ADDENDUM FOR LV SERIES IOM

MANUAL (PART# 8 733 822 471 Initial Release 8-18)

This addendum intention is to provide information on changes to the LV018, 024, 030 & 036 models, highlighting only the difference from current LV018, 024, 030 & 036 models; where applicable, with reference to the main LV IM (P/N 8733944336).

Figure #2 – LV Horizontal Cabinet Dimensions

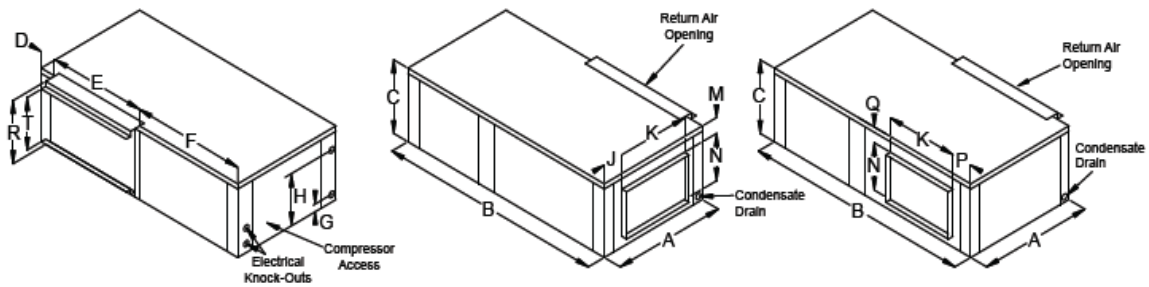
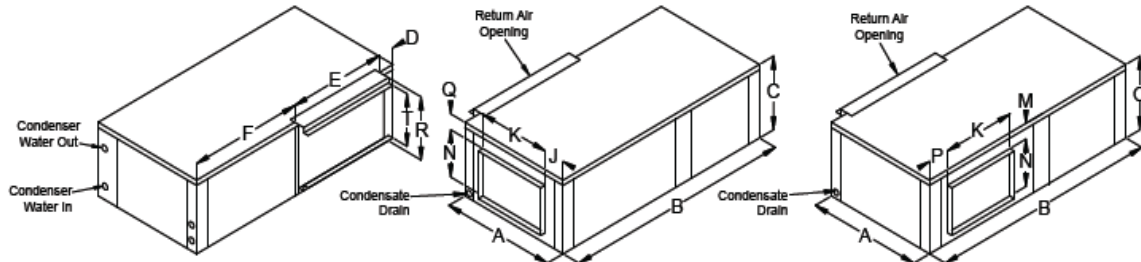
HORIZONTAL CABINET EFFECTS:

Horizontal Unit Dimensions																		
Overall unit dimensions do not include filter rack or duct flanges.																		
Model	A	B	C	D	E	F	G	H	J	K	M	N	P	Q	R	T	Condenser Water Connections	Recommended Replacement Nominal Filter Size
	Width	Depth	Height	Cabinet End to Filter Rack	R/A Duct Width	Cab Front to Filter Rack	Water Inlet	Water Outlet	Side to Discharge (End)	Discharge Width	Top to Discharge (FLE & FRS)	Discharge Height	End to Discharge (Straight)	Top to Discharge (FRE & FLS)	Filter Rack Height	R/A Duct Flange Height		
LV024	22.0	43.0	18.0	1.5	25.0	16.5	2.86	14.13	5.42	9.13	6.11	9.65	4.92	1.23	16.8	15.0	3/4" FPT	16 × 25 × 1
LV030	22.0	43.0	18.0	1.5	25.0	16.5	2.47	15.0	5.42	9.13	6.11	9.65	4.92	1.23	16.8	15.0	3/4" FPT	16 × 25 × 1

Figure #3 – Overload Relay E-Box Mounting Location

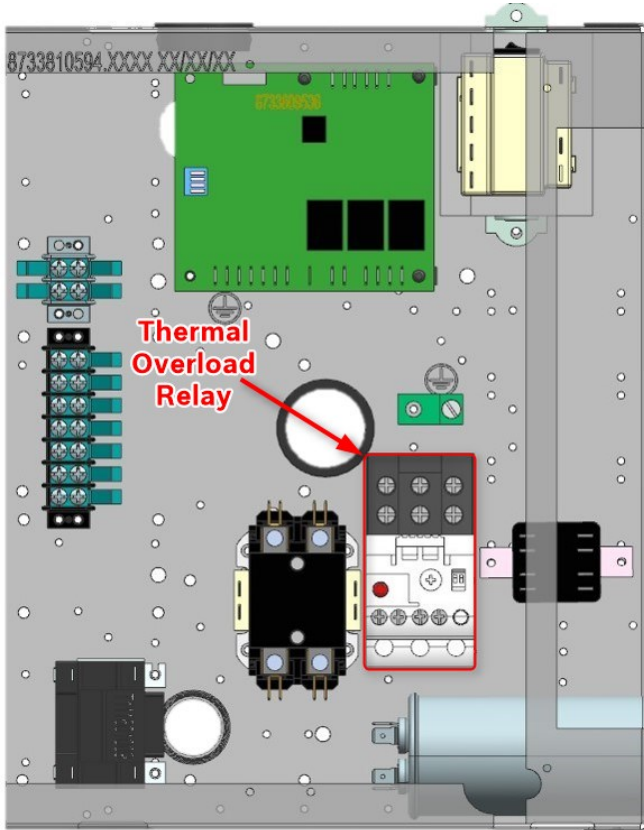
Thermal Overload Relays are used on 036-1 PSC & EON blower equipped units and all 036-2 units. Prior to energizing these units, visually verify the amperage setting of the overload relay is set as defined below in Figures #3 - 5.
